# City of Portland Historic Landmarks Commission

## Design Advice Request #3

### SUMMARY MEMO

**Re:** EA 22-184037 DA – Jefferson High School Development  
Design Advice Request #3 Commission Summary Memo – November 20, 2023

# 1928 Gym - alignment with new school massing

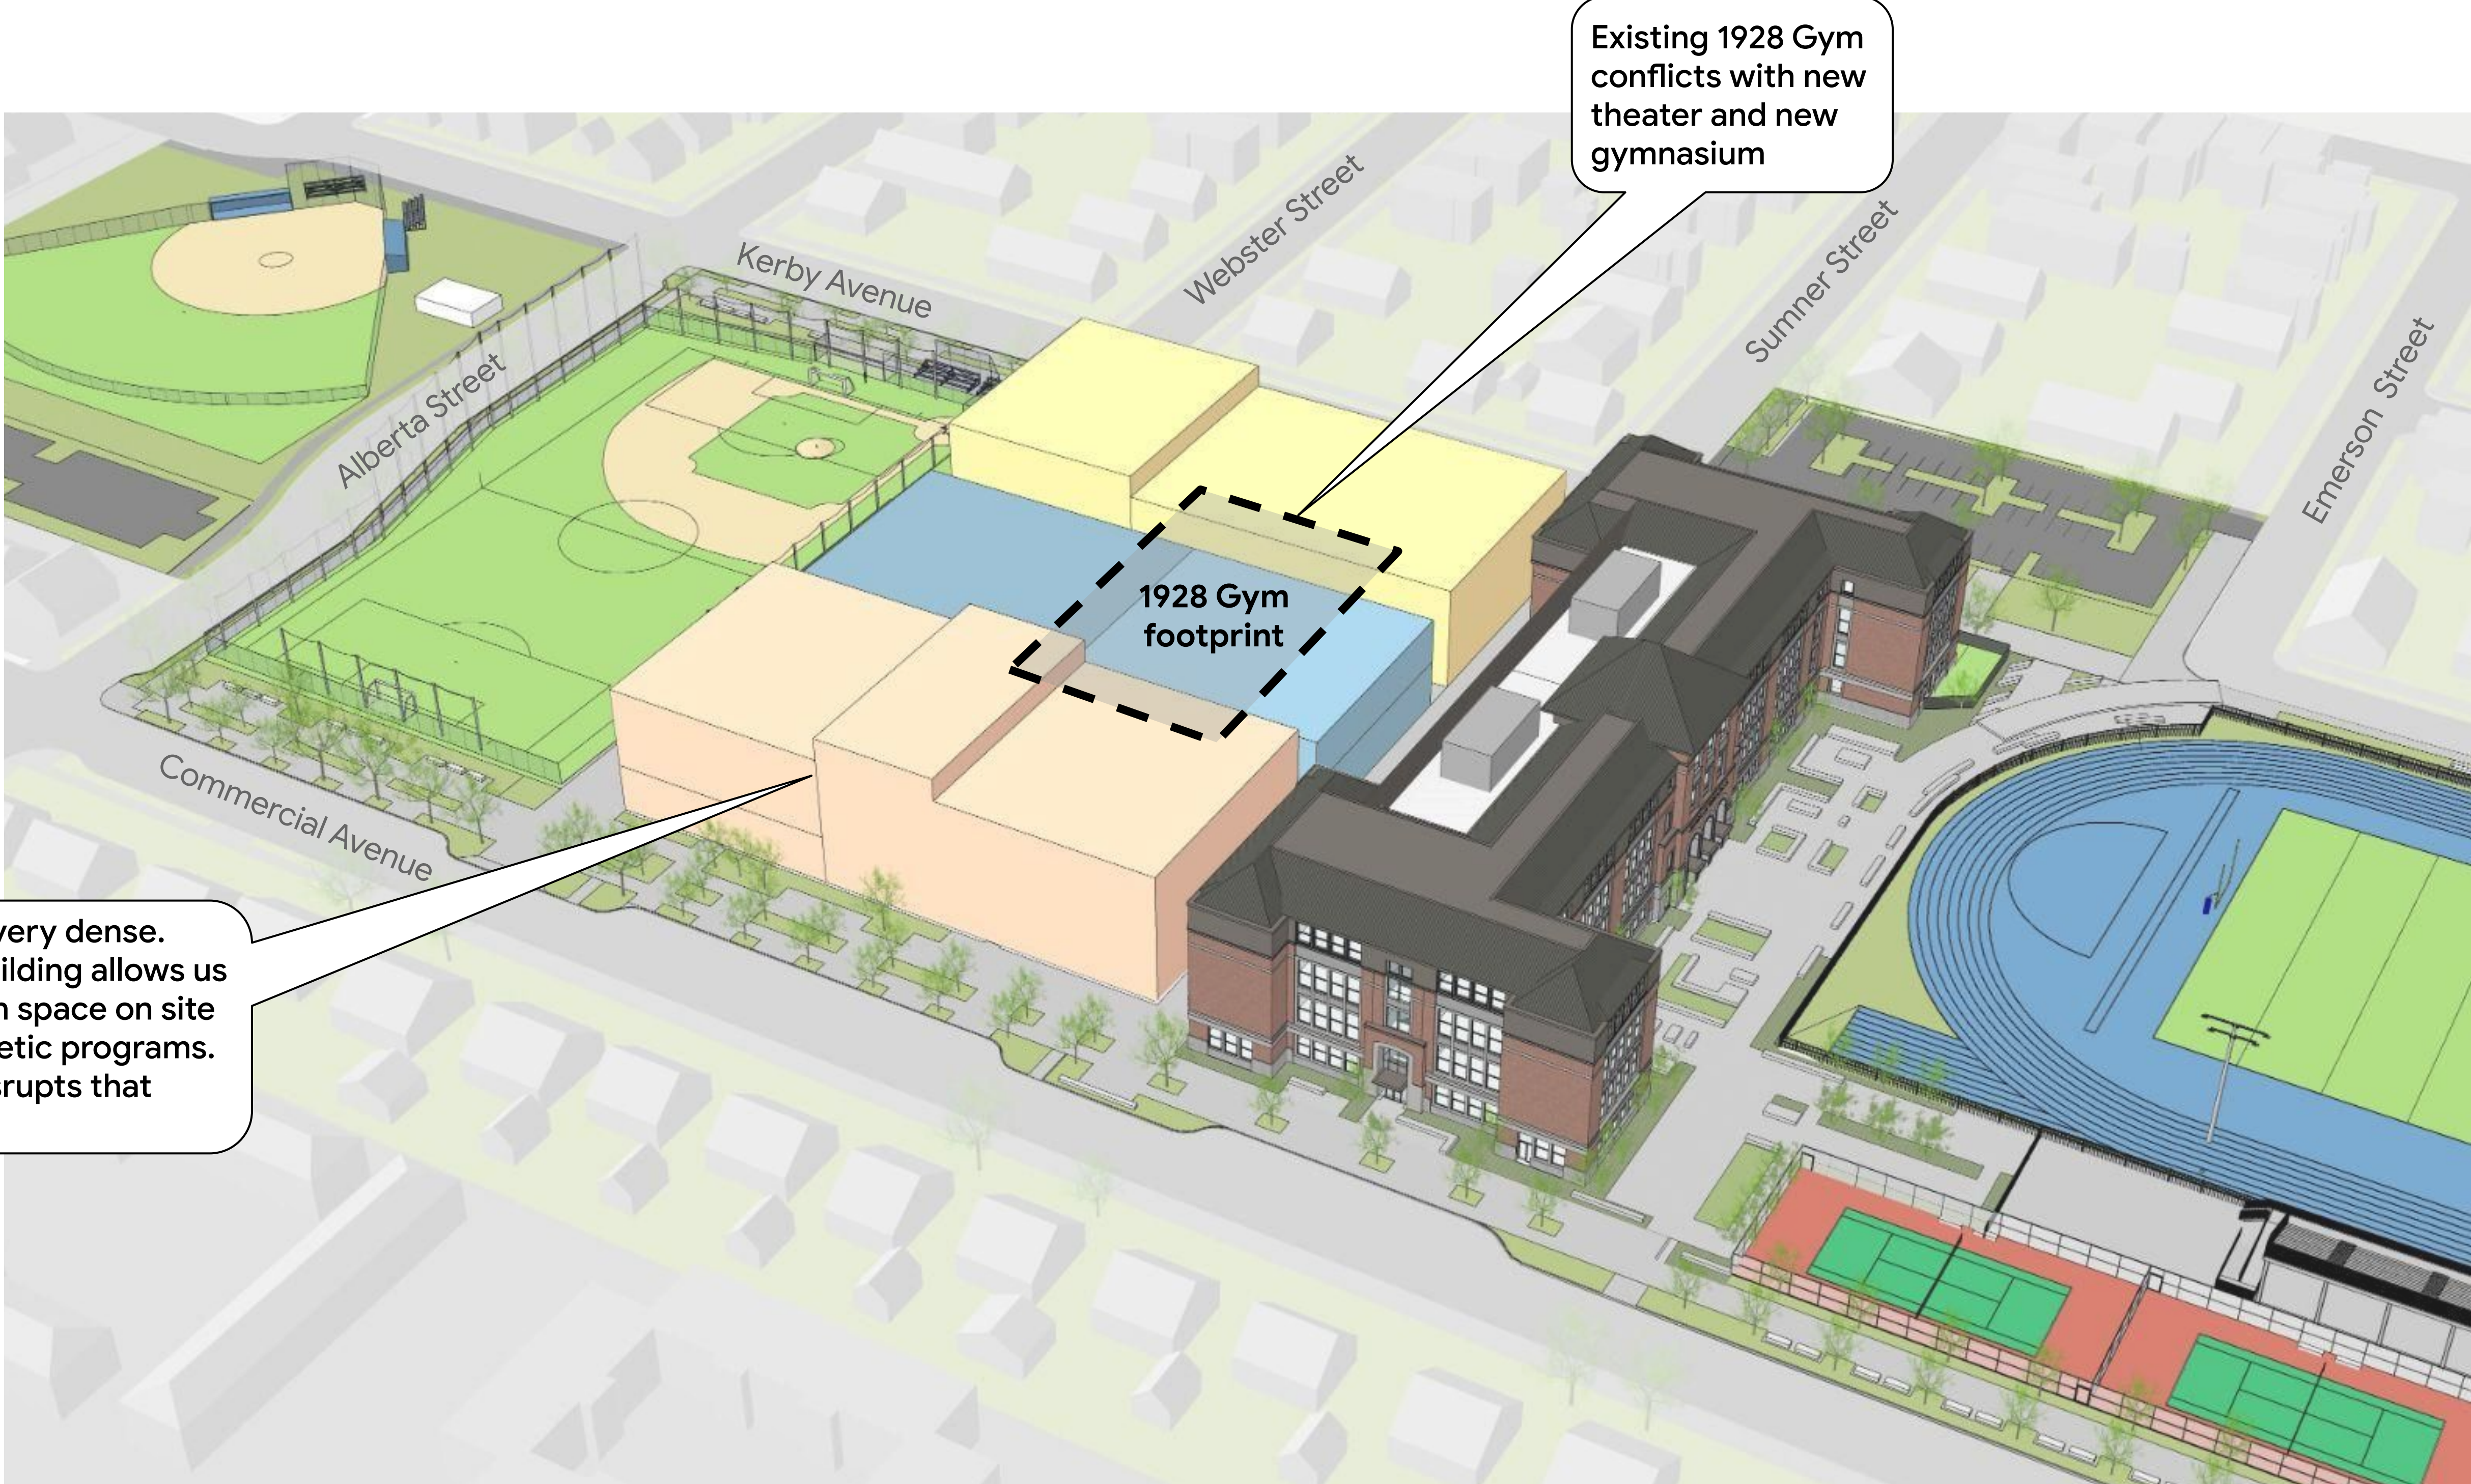
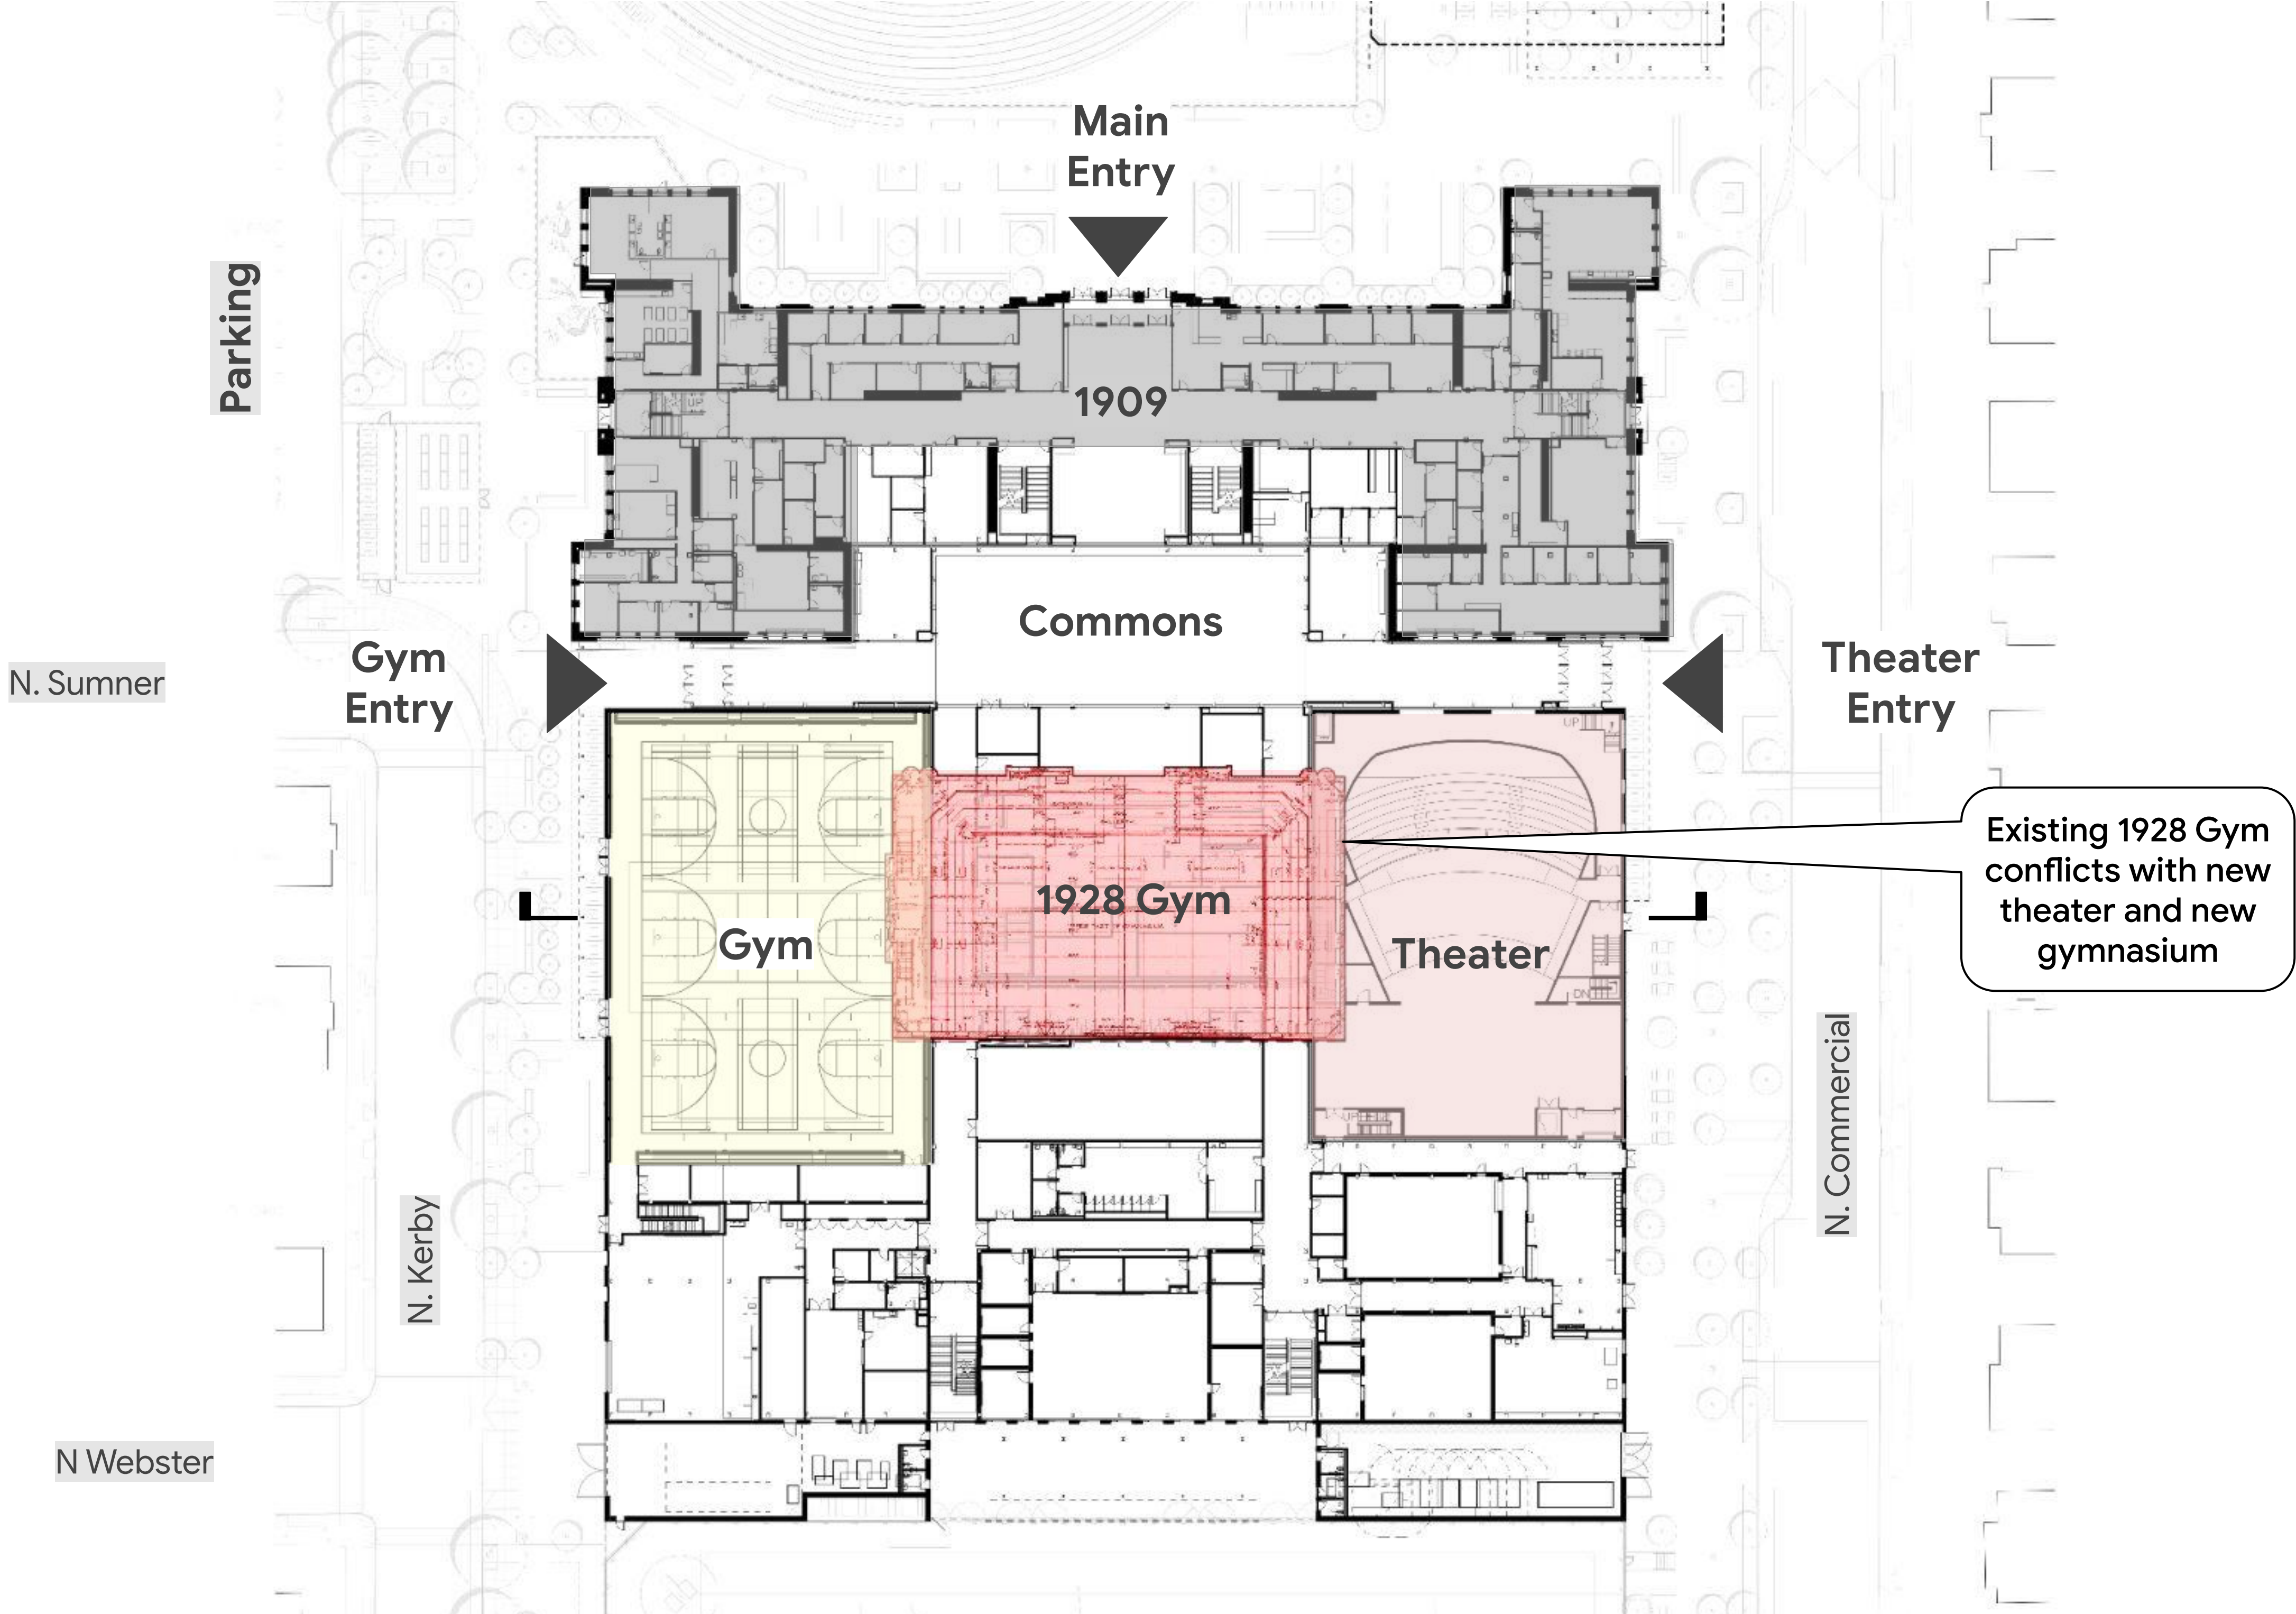
### 1928 Gym - the team needs a clearer case for the removal of 1928.

Existing 1928 Gym conflicts with new theater and new gymnasium

New addition is very dense. This compact building allows us to preserve open space on site for required athletic programs. Keeping 1928 disrupts that density.

**Current Design**  
West Elevation

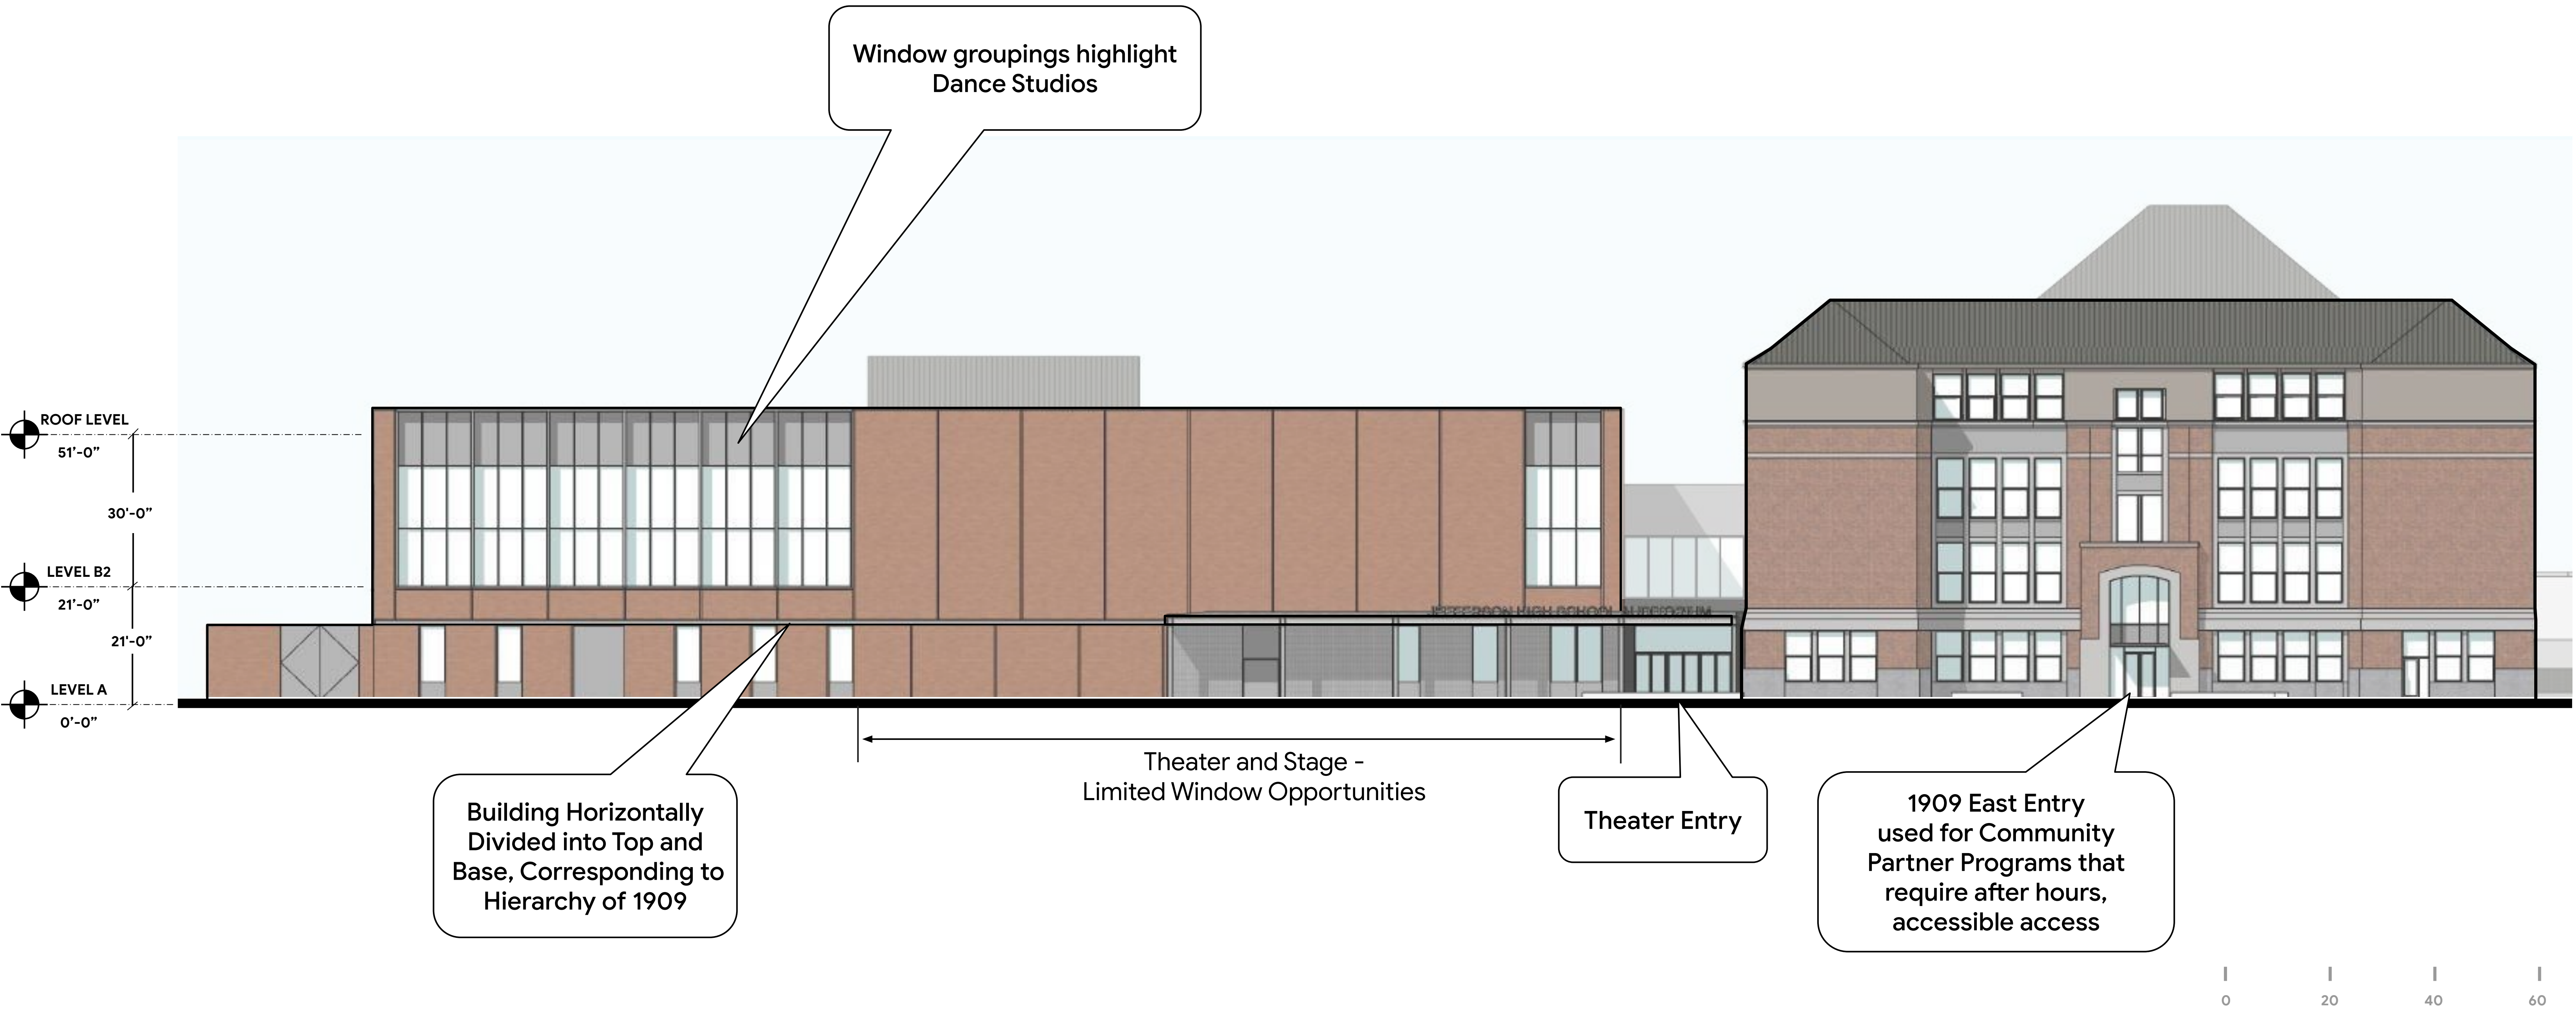
- Commissioners continued to request additional measures on the new east and west elevations to break up the monotony of the facades and ensure a successful ground level. Alternatives to windows such as fin detailing referenced from the proposed curtain wall system were suggested. Additional brick detailing (referencing brick detailing on the 1909 building), landscaping (green wall), seating/benches, and murals were also suggested as devices to provide an improved ground floor for pedestrians as well as depth and texture to the architecture.

- Commissioners agreed the current proposal's ground floor on the new east and west elevations contains too much blank façade (brick) and should provide increased glazing or other features that support a successful pedestrian environment. To reduce monolithic blank wall facades, Commissioners suggested the addition of shallow storefronts on the theatre elevation including a marquee to provide additional visual interest. One Commissioner suggested built in seating. Commissioners continued to request that the applicant consider

Added Canopies and  
Material Change at  
Entries

Program Shifted to  
Provide More  
Activated Presence  
at Sidewalk
